# UNITED STATES PATENT AND TRADEMARK OFFICE

APPLICATION NO.	FILING DATE	FIRST NAMED INVENTOR	ATTORNEY DOCKET NO.	CONFIRMATION NO.
10/668,734	09/23/2003	John J. Toben	6006-141-1	2477

**Office Action Summary**

FIG. 4

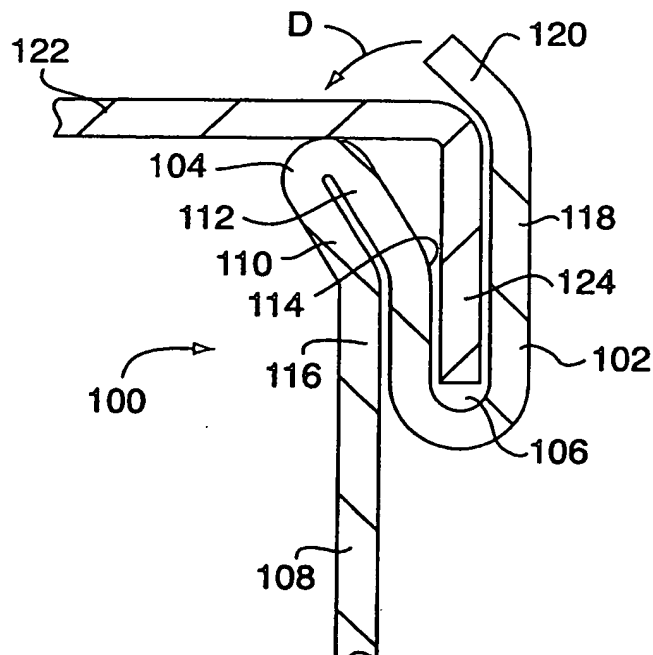
The drawings are objected to as failing to comply with 37 CFR 1.84(p)(4) because reference characters "108" and "116" have both been used to designate the same duct wall in Figure 4.
